Product Change Notification

Date Issued :	September 01, 2022	PCN Number :	512593
Reason for Change :	Change Supplier		
Description of Change :	This notification is to inform you about addition of new Supplier impacting the part(s) as per attached list. No changes will be made to product as part of this change		
Reason for Short Notice :	Supplier Constraints		
Assessment of Change :	First Article Inspection		
Planned Implementation Date :	December 15, 2022		
Sample Availability Date:	September 01, 2022		
Internal Molex Qualification Date :	September 01, 2022		
Last date to request Samples by Customer :	September 23, 2022		
Traceability Code Markings / Date :	Lot information on label

IMPEL 6P DAUGHTERCARD PRODUCT ILLUSTRATION

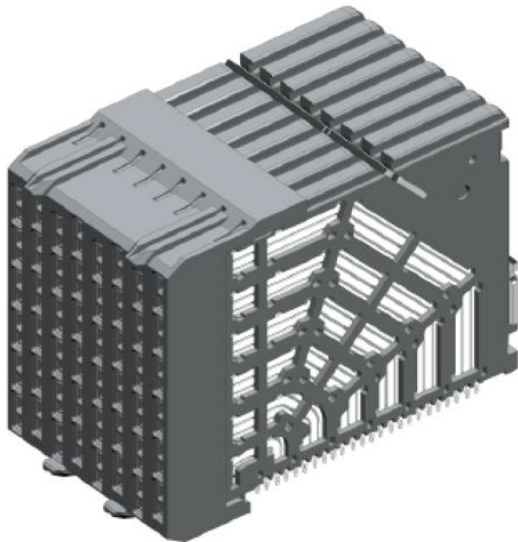
- As a valued customer, we wanted to notify that:
 - ❖ Due to Resin Supply constraint, Molex shall add new source of Resin used at Impel 6P Daughtercard product family series with new supplier Celanese.
 - ❖ Molex internal qualification would be conducted to ensure it meets product specifications before implementing the change.
 - ❖ No impact to form, fit and function of the products
- Part Number Impact
 - Refer to attached impacted part no list
- Samples available upon request
- Qualification Reports available upon request after the date shown above
